Work Order ID 141147

Item Name: Replacement Skidtube (Fits LH or RH)

DRAWING NO. D2650	TITLE 206/407 SKIDTUBE ASSEMBLIES	REV. F	DART AEROSPACE LTD ENGINEERING ORDER		D.E.O. NO. D2650-F-1	SHEET NO. SHEET 1 OF 1	SCALE NTS
DRAWN <i>[Signature]</i>	CHECKED <i>A.P.</i>	MFG. APPR. <i>[Signature]</i>	APPROVED <i>[Signature]</i>		DE APPR. <i>[Signature]</i>		
DATE 12.10.12	DATE 12.10.22	DATE 12.10.22	DATE 12.10.22		DATE 12.10.22

CHANGE C'BORED WELDED CROSSBOLT SPACERS TO SWAGED SPACERS

AMENDMENT TO DETAIL B
NOT TO SCALE

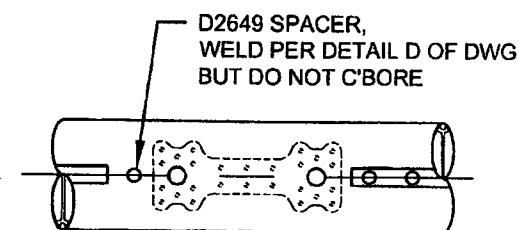
ADD DETAIL G BELOW, WHICH IS THE SAME SECTION VIEW AS DETAIL D OF DWG.
C'BORED HOLES ARE **NOW SWAGED** PER DETAIL G BELOW. FOR THE Ø0.375 HOLE THAT IS NOT C'BORED, WELD PER DETAIL D OF DWG (SEE AMENDED DETAIL B FOR REFERENCE).

DETAIL G

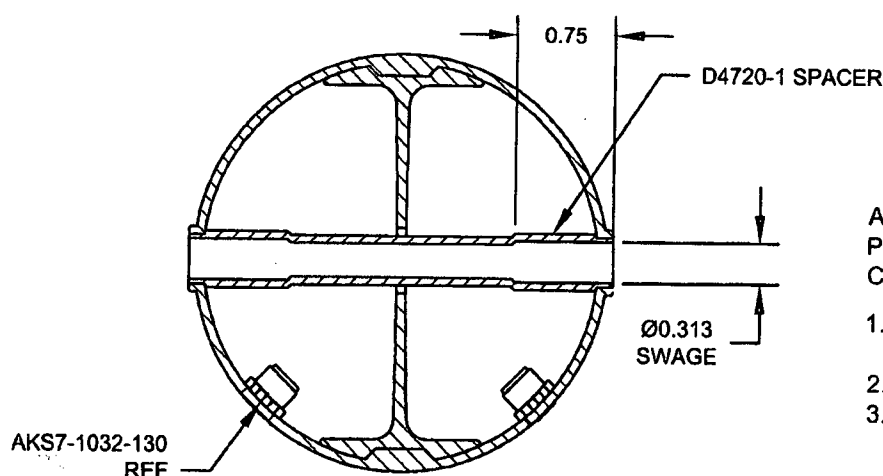
AFTER DRILLING AND BENDING ASSEMBLY
PERFORM THE FOLLOWING FOR Ø0.375 HOLES THAT ARE
CURRENTLY C'BORED:

1. INSERT D4720-1 SPACER, 16 PL (-1) OR 17 PL (-3)
OR 19 PL (-5) OR 23 PL (-7)
2. SWAGE TO Ø0.313 X 0.75 DP PER QSI 002
3. TRIM / GRIND FLUSH PER QSI 002
